County of Loudoun  
Office of Transportation Services

MEMORANDUM

**SUBJECT: ZMAP 2008-0023—Cedar Green Church  
Second Referral**

CONCEPT PLAN  
 (ZMAP 2008-0023)  
**CEDAR GREEN CHURCH**

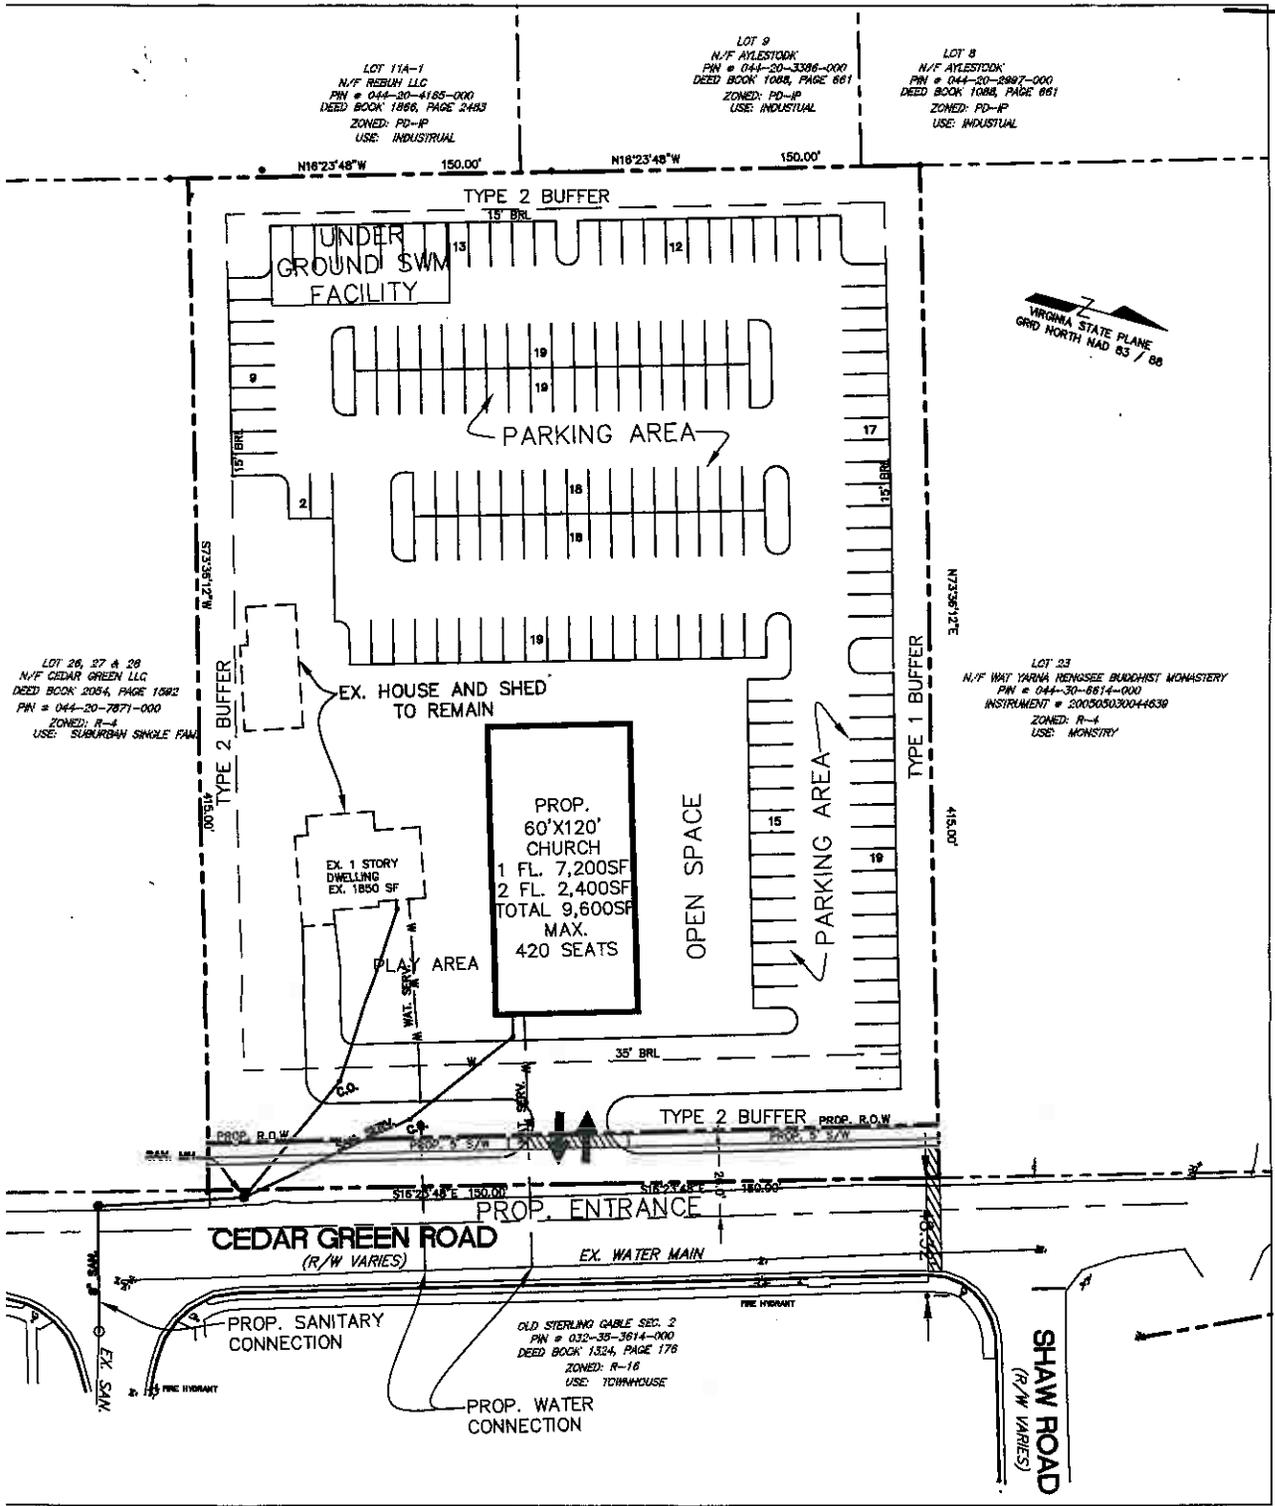
**Issue Status:** A total of 180 parking spaces are depicted on the concept plan. OTS defers to the Department of Planning and the Department of Building and Development (Zoning Administration) regarding the appropriateness of excess parking on site.

**Issue Status:** The concept plan depicts an additional 20 feet of ROW dedication along the site frontage, which would allow for approximately 52 feet of pavement (curb to curb) along Cedar Green Road. A 5-foot sidewalk is also depicted within the proposed ROW along the site frontage, as are what appear to be crosswalks. The Applicant should clarify its intent regarding the timing of these proposed improvements (ROW dedication and road, sidewalk, and crosswalk construction); this type of information is typically specified in a proffer statement, though no proffers were included for OTS staff review. OTS recommends that all improvements be constructed and available for use prior to opening of the proposed church.

**Issue Status:** No entrance is shown on STPL 2004-0030; the Applicant should clarify the specifics of the entrance proposed.

4. On June 2, 2009, the Board of Supervisors passed a resolution (provided as Attachment 2) indicating its preference regarding the alignment of the future east-west segment of Shaw Road in the Belfort Park area. The Board's resolution calls for a two-lane (U2) road section within a 50-foot ROW extending west from the current east-west Shaw Road alignment, which would place the road along or just north of the site's northern boundary. This location has been included on the current draft of the *Countywide Transportation Plan* currently under review by the Planning Commission. Given this alignment, OTS staff suggests that the Applicant consider designing its proposed parking area (in the northwest

corner of the site) to accommodate a future ingress/egress access point to this future road.
